XT303-S939

Thermostat Housing Hose –
Install Additional Hose Clamp –
Service Action S939

MODEL 2002-03 MY
X-TYPE

VIN C00294-D28259
D29261-D32144

ILLUSTRATION 1

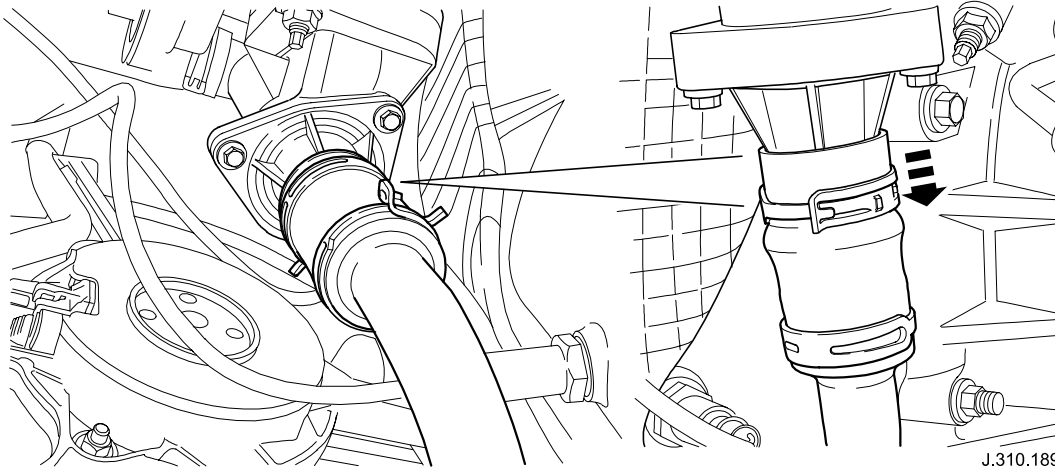
On a number of X-TYPE vehicles within the above VIN range, the spring band clamp used on the hose joint between the engine oil cooler outlet hose and the thermostat housing inlet spigot is susceptible to ‘walking’. In extreme cases this can lead to the failure of the joint causing loss of engine coolant.

3. Reposition the hose fully upwards to abut the thermostat housing webs.
4. Reposition the spring band clamp close to the bulge in the hose formed by the bead of the thermostat spigot. Illustration 1.

Note: Spring band clamp to be close to, but not on the hose bulge.

ILLUSTRATION 2

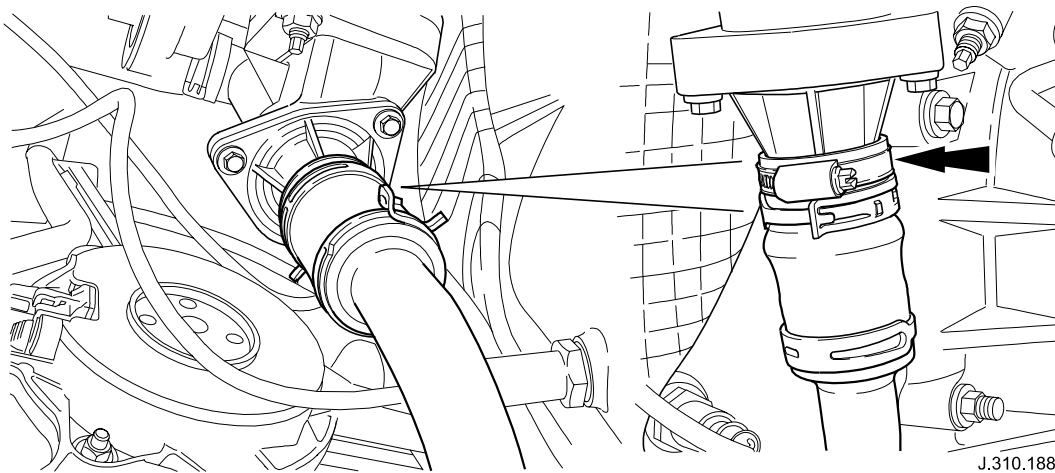
Reposition the existing hose clamp and install an additional worm drive clamp to prevent the hose from moving.

5. Fit an extra 9 mm wide, 32-50 mm Norma worm drive clamp above the existing spring band clamp and tighten to 4.1 Nm +/- 0.7 Nm tolerance. See Illustration 2.

Note: Fit worm drive clamp against the spring band clamp so that the hose protrudes above the worm drive clamp.
